**Re: Del Norte Baptist Church  
5800 Montgomery Blvd. NE  
Grading & Drainage Plan Engineer's Stamp Dated 8/1/17  
(G18D010)**

Based upon the information provided in the submittal received on 8/2/17 the above-referenced plan cannot be approved for Grading, SO-19, and Paving Permits.

Project No. 21635  
Drawn By: WCM  
Checked By: ds  
Date: 05.26.2017  
Sheet No. **C102**

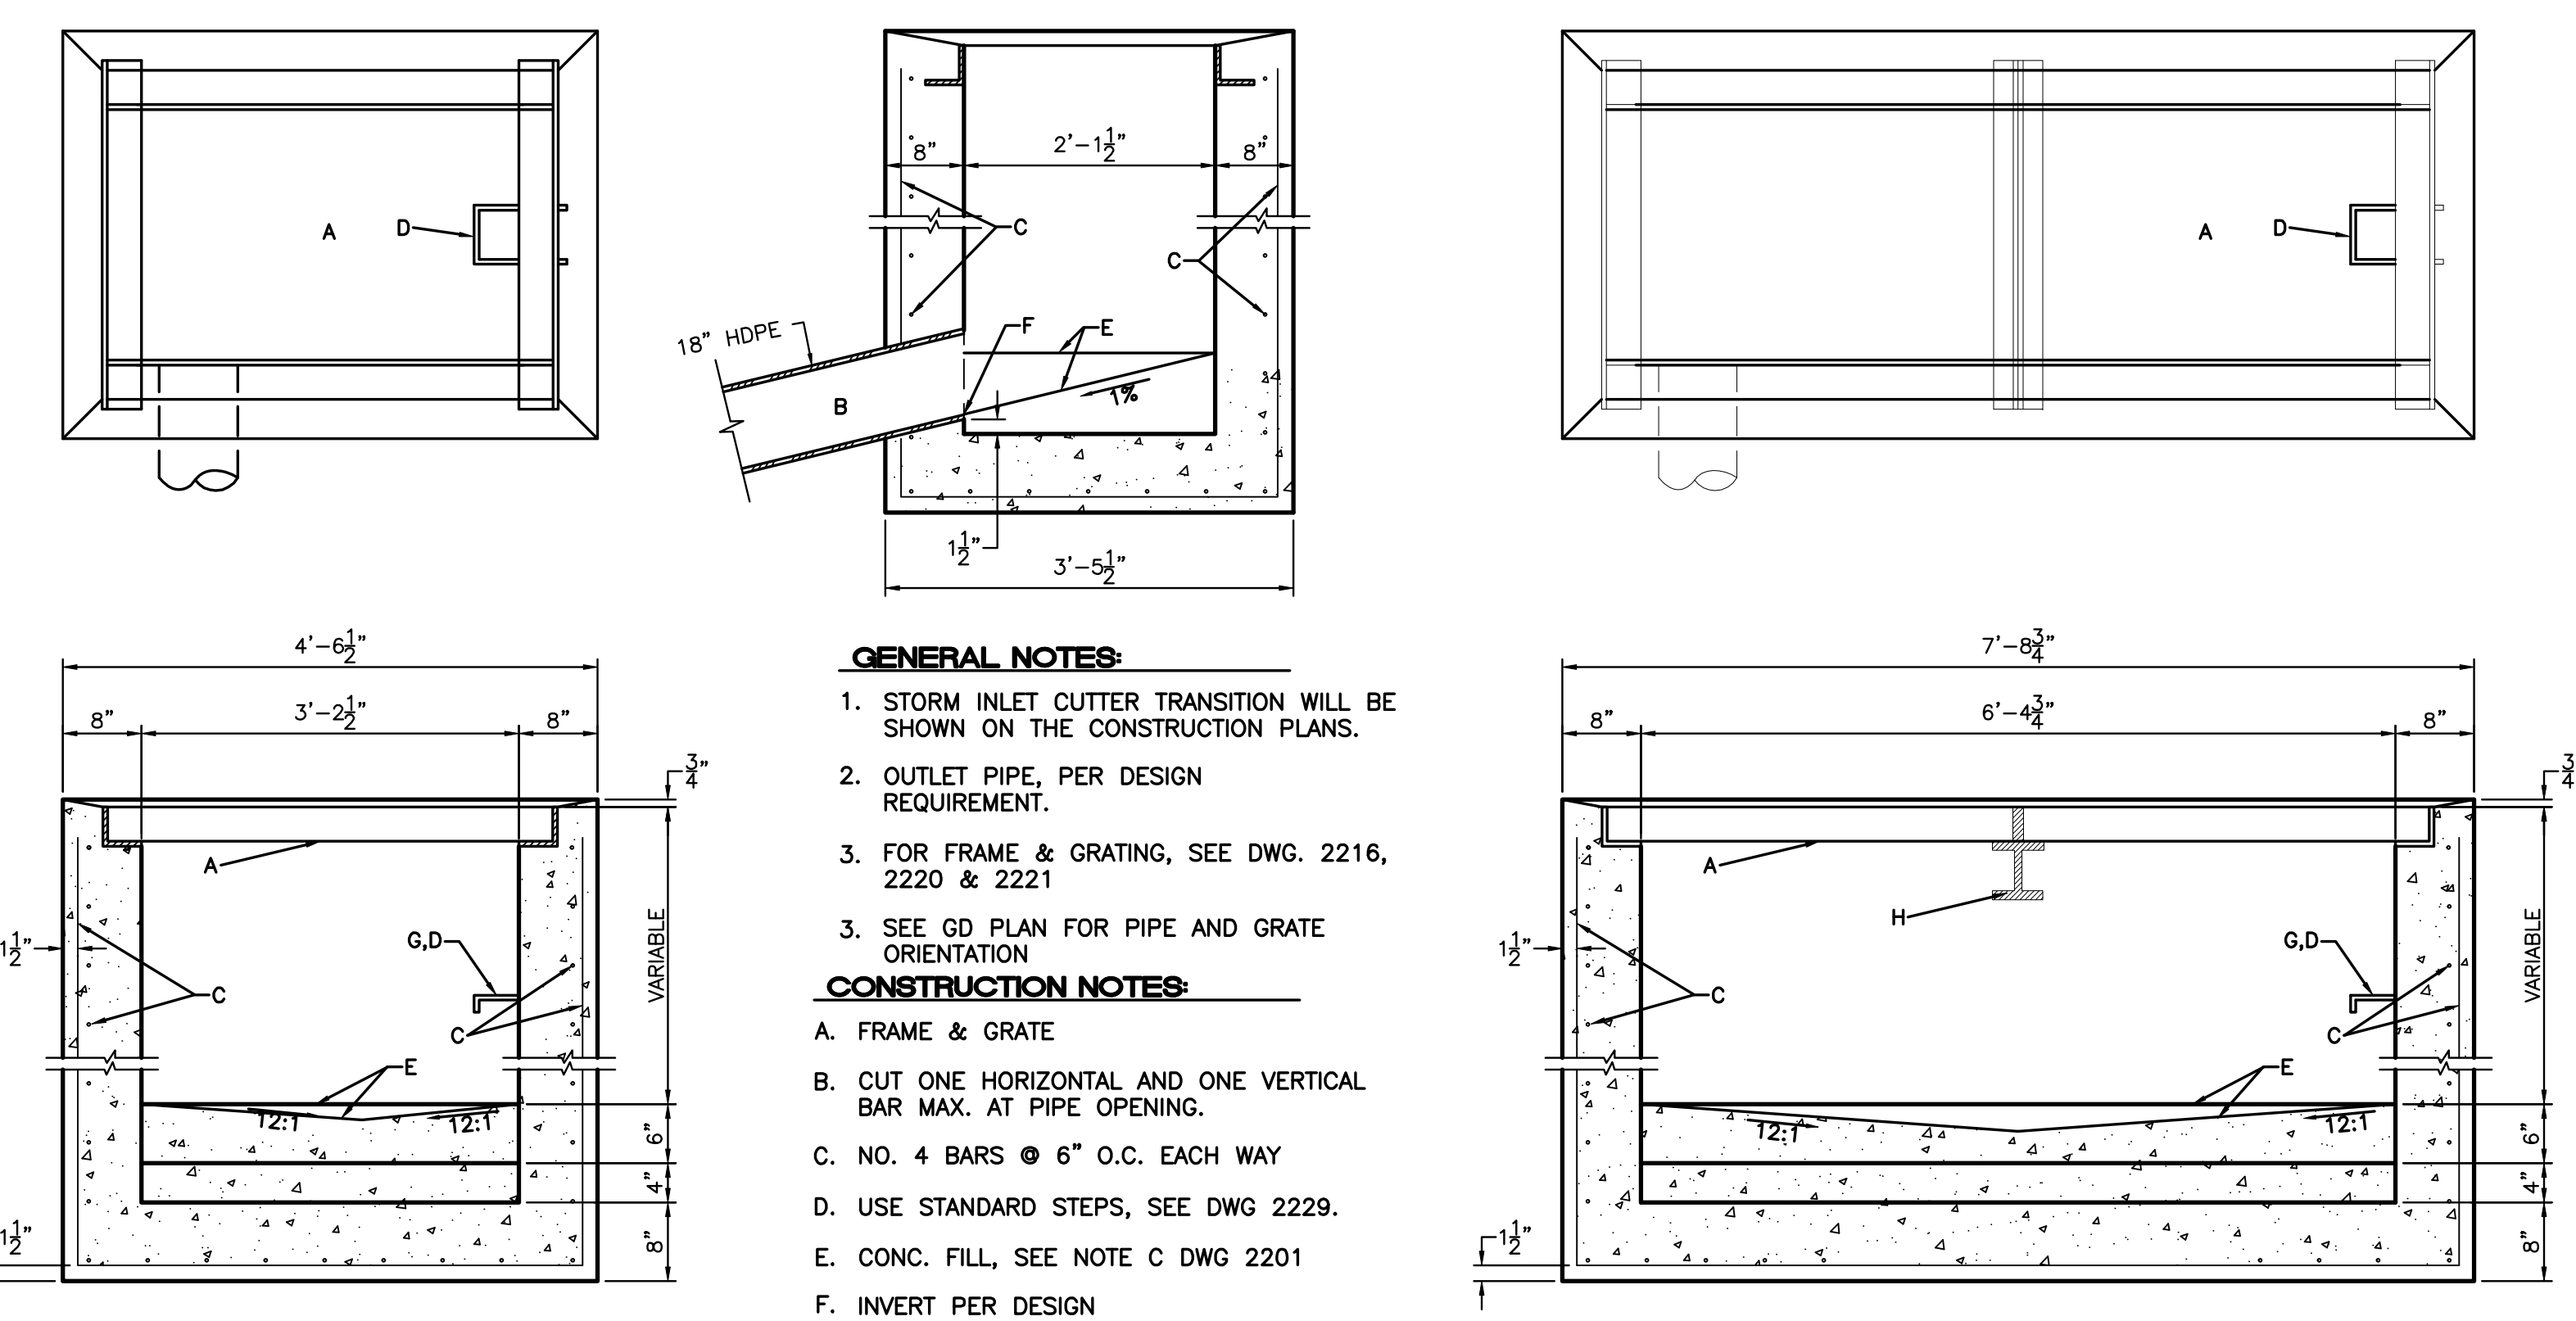
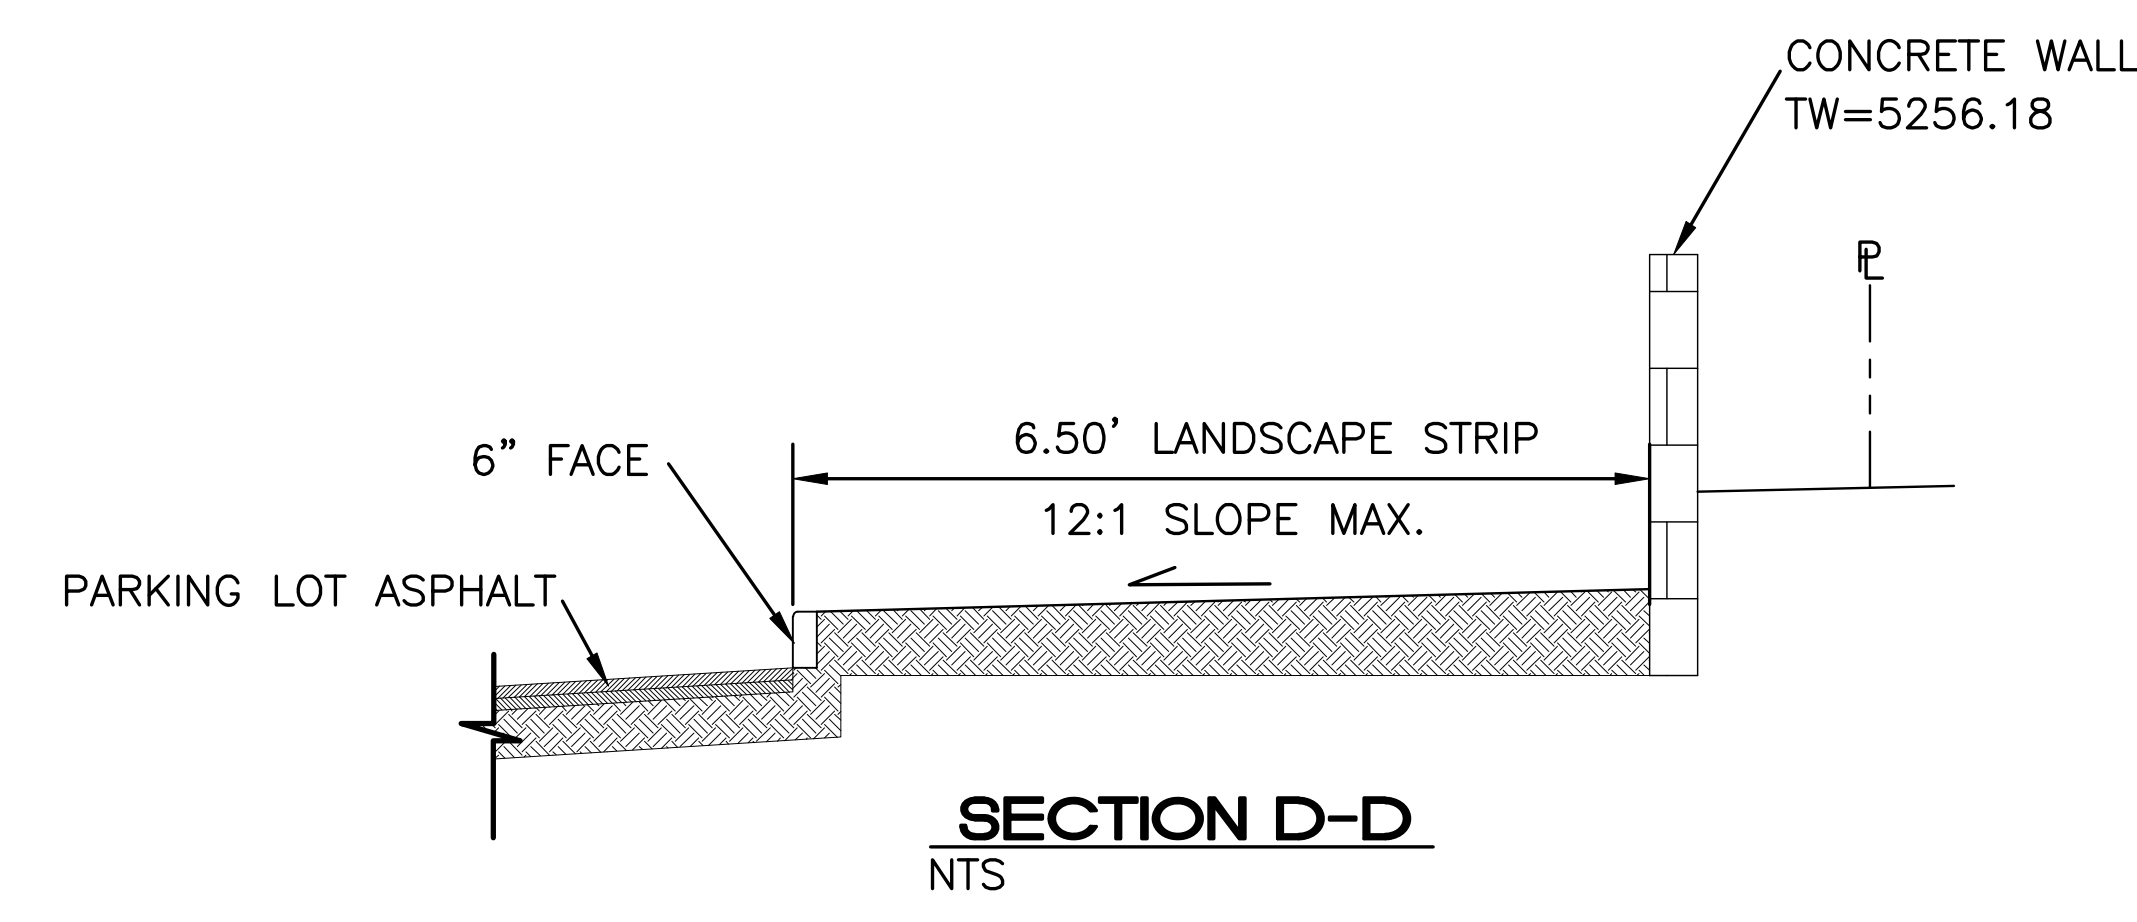
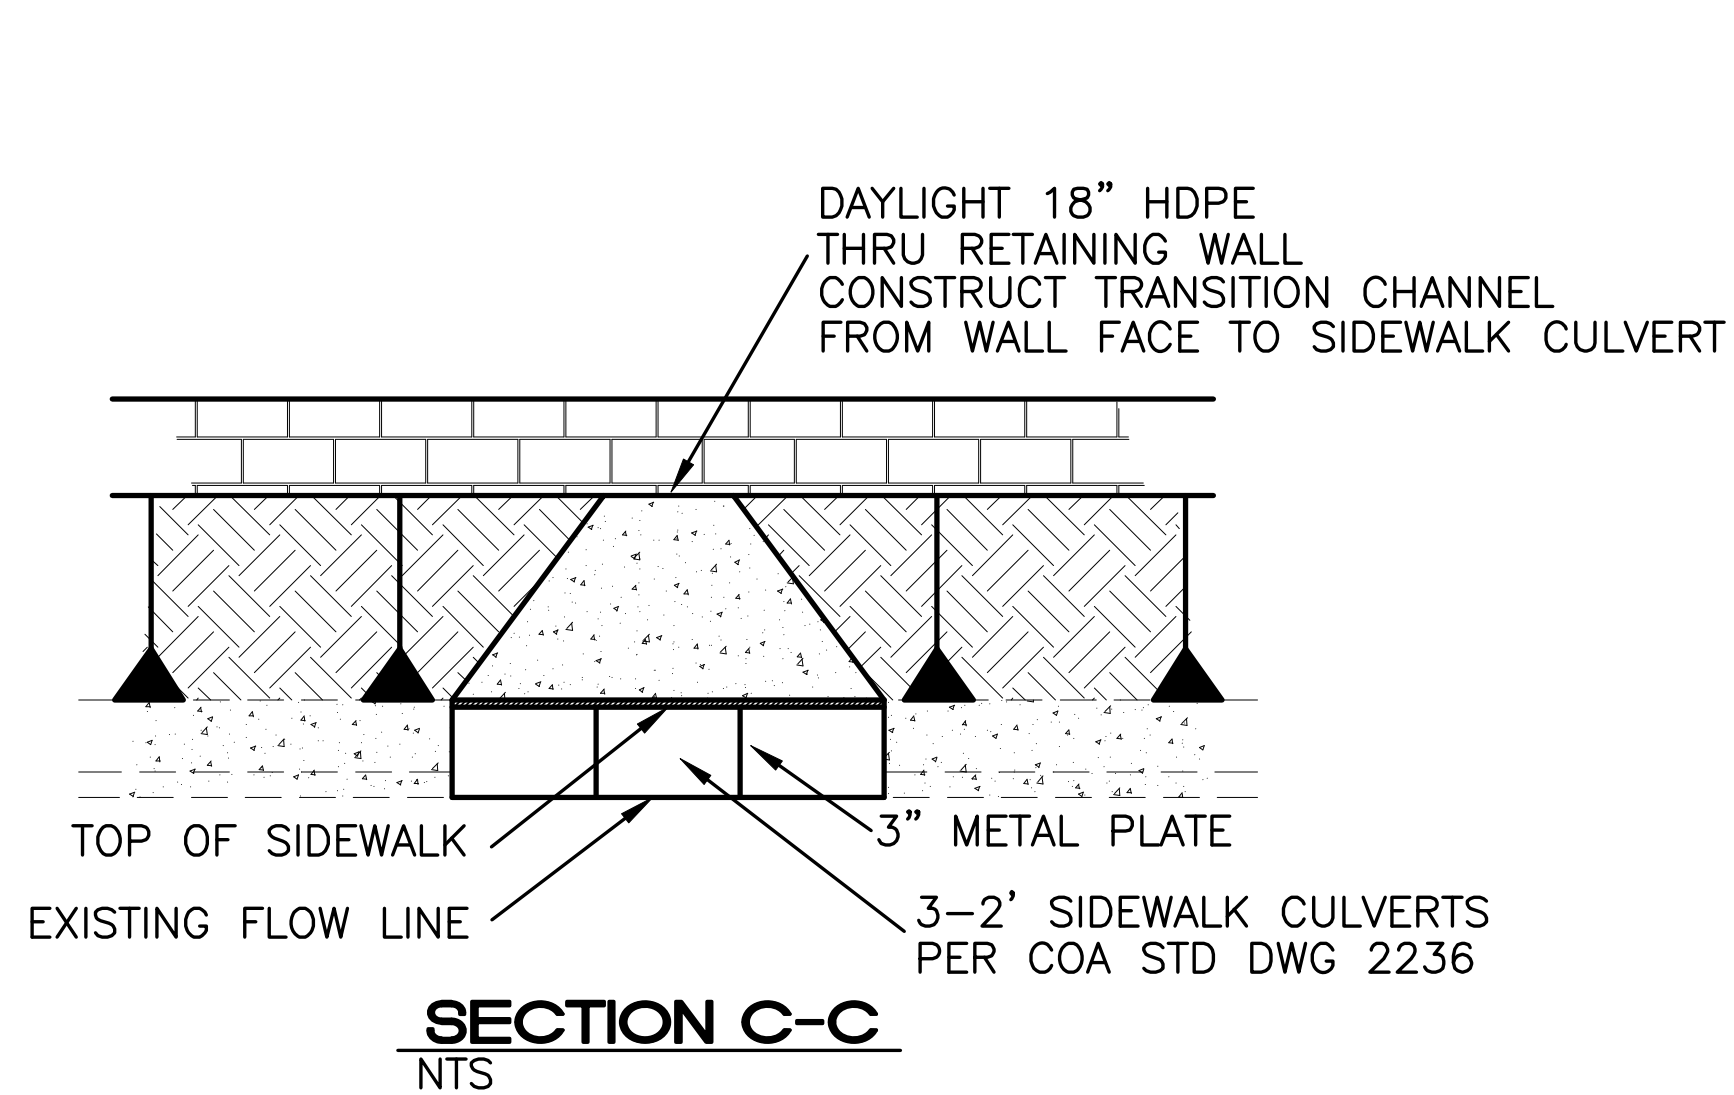
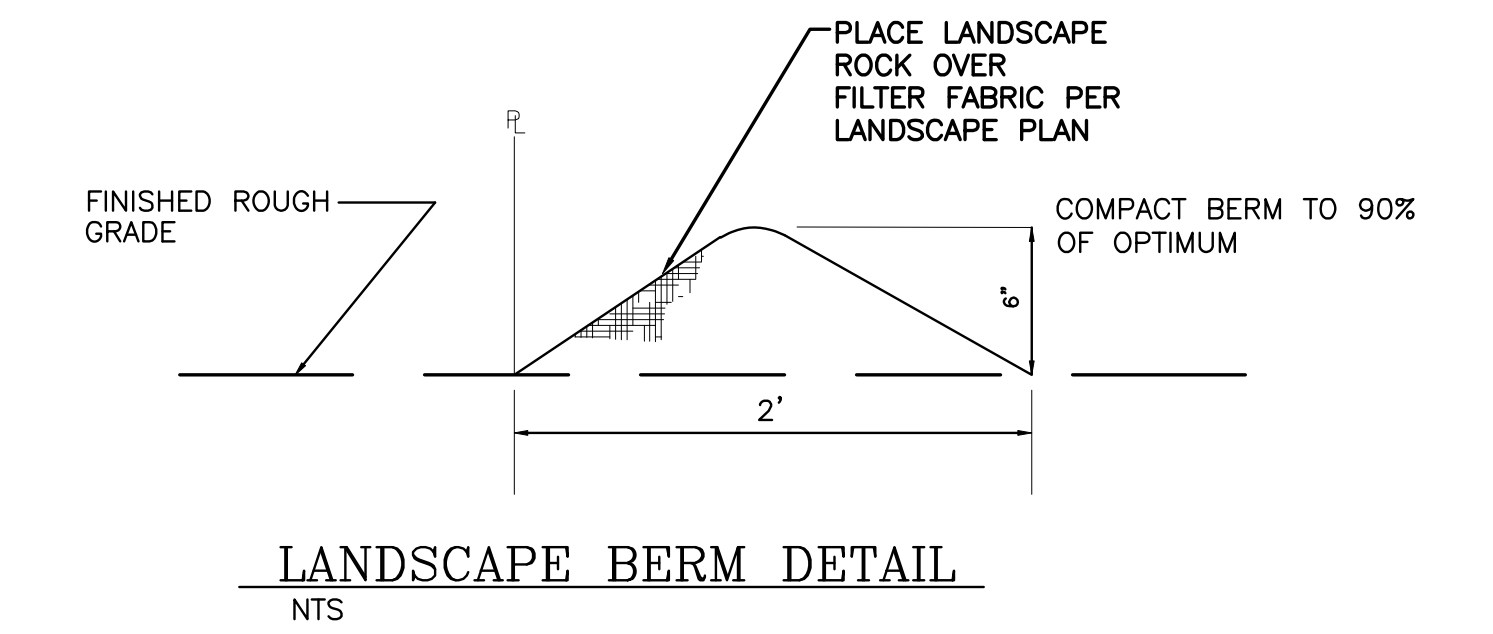
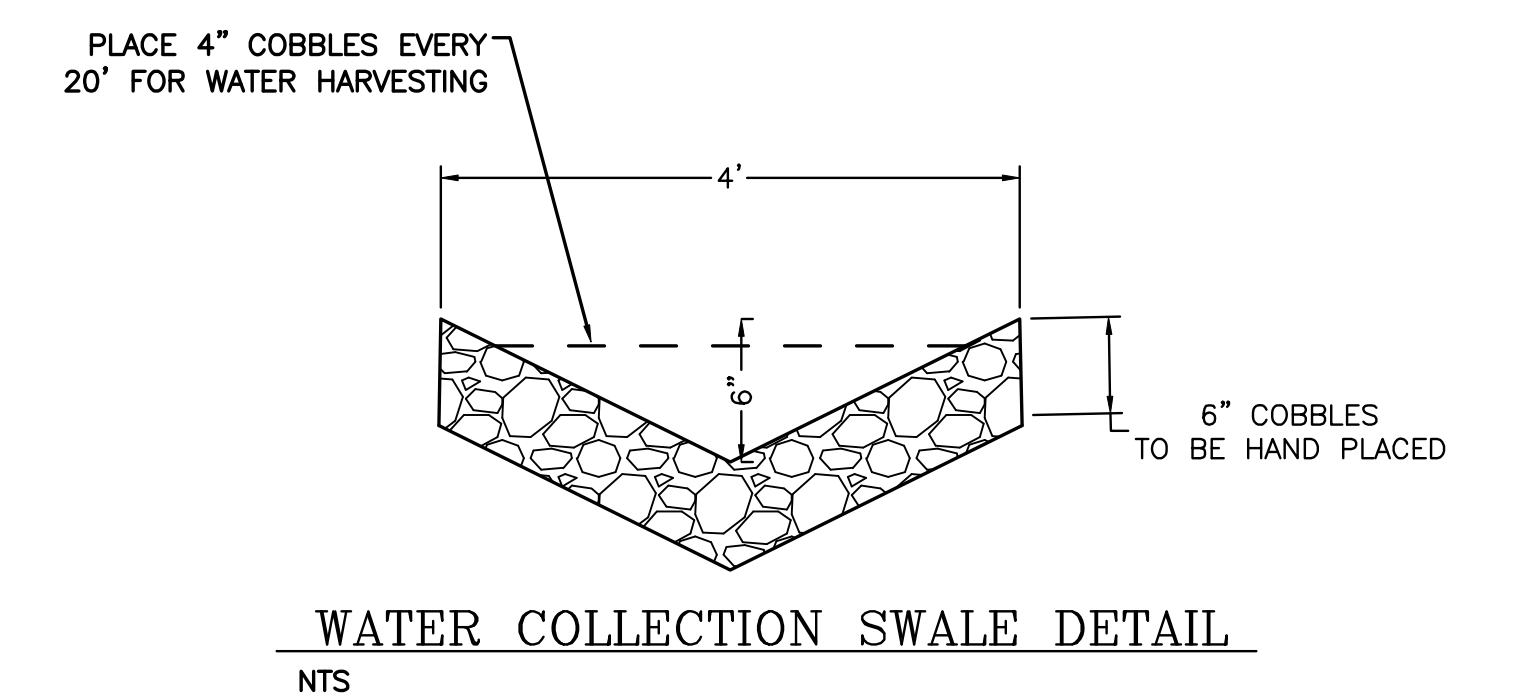
- Add more typical sections around perimeter of site. More retaining walls may be needed particularly along the west side of lots C and B. Show existing walls/slopes in sections.

- Typical section DD needs more dimensions, show footer, existing ground distance to property line, and max height of retaining. Offset the wall far enough from property line so that the neighbor's property will not be disturbed during construction.
- Add existing ground and dimensions to Section BB
- Provide more sections and details for grading in landscape areas northeast of the building.
- Provide HGL calculations for onsite storm drain and add profile of pipe to the plans showing HGL and label HGL elevations, Q, and V.
- Provide actual flow depth & elevation at inlets. Add emergency overflow depth & elevation calculations for sump inlets and verify freeboard to building floor elevations.
- Provide section, profile, and details of ponds F and G. Make sure they do not drain into the private property west of this site. Provide outfall details.
